McKinley Road Redevelopment Phase Three 715 McKinley Road, 361 Westminster Condominium Building & Single Family Residence

STAFF REPORT AND RECOMMENDATION

TO:	Chairman Grinnell and members of the Historic Preservation Commission
DATE:	November 16, 2022
FROM:	Catherine Czerniak, Director of Community Development
SUBJECT:	McKinley Road Redevelopment Phase Three – Condominium Building and Single Family Residence

361 E WESTMINSTER
ELEVATIONS

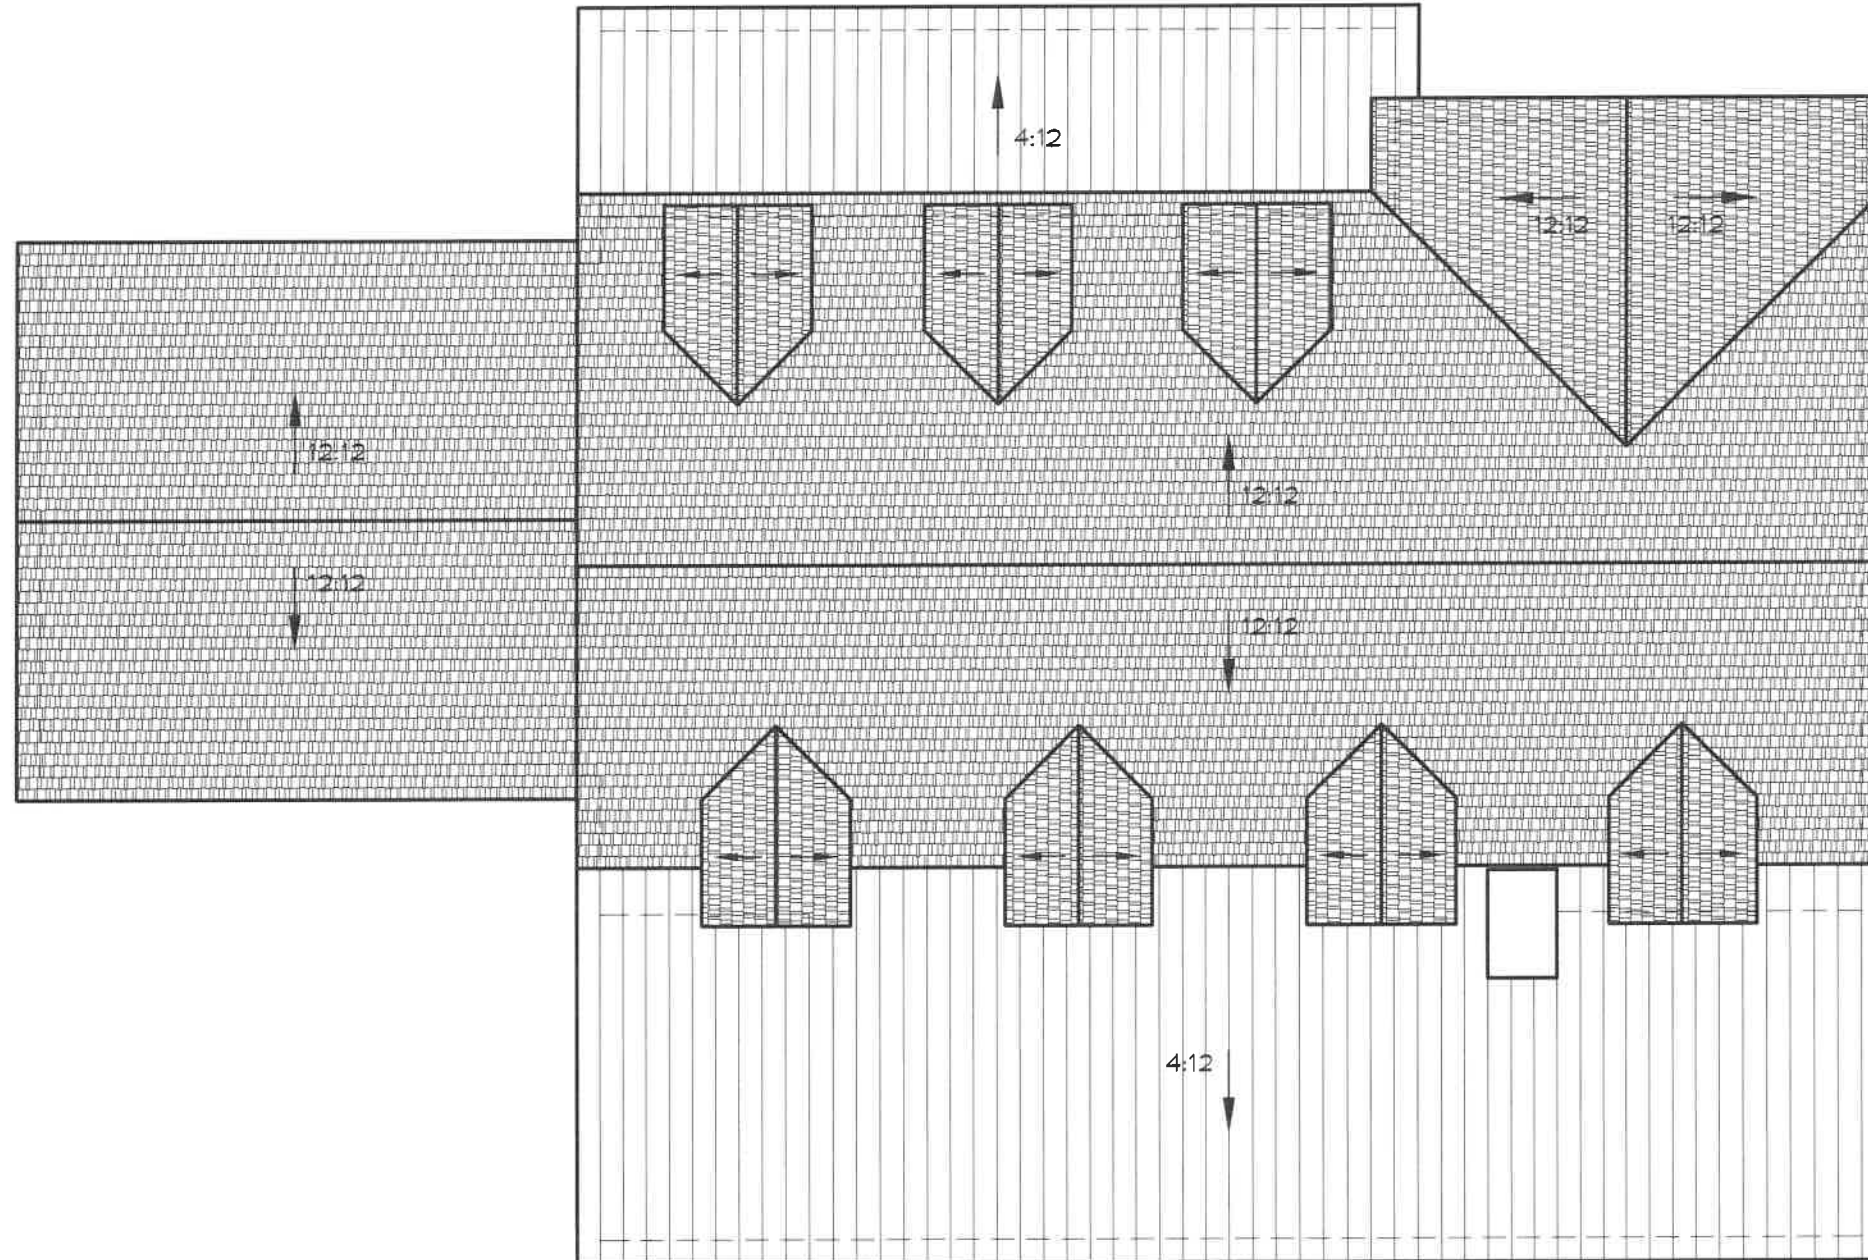
This standard is generally met. The proposed openings around the home are mostly double hung windows with some smaller square windows in the gable ends and in the garage. The 6 over 6 muntin pattern in the double hung windows is consistent with the traditional style of the home. Some windows on the second floor on the north and west elevations appear to crowd the space on the gable ends, consideration should be given to reducing the size of the windows in these areas.

3. The large double hung windows on the north and west elevation of the gable ends of the single family residence shall be reduced in size to avoid a crowded appearance.
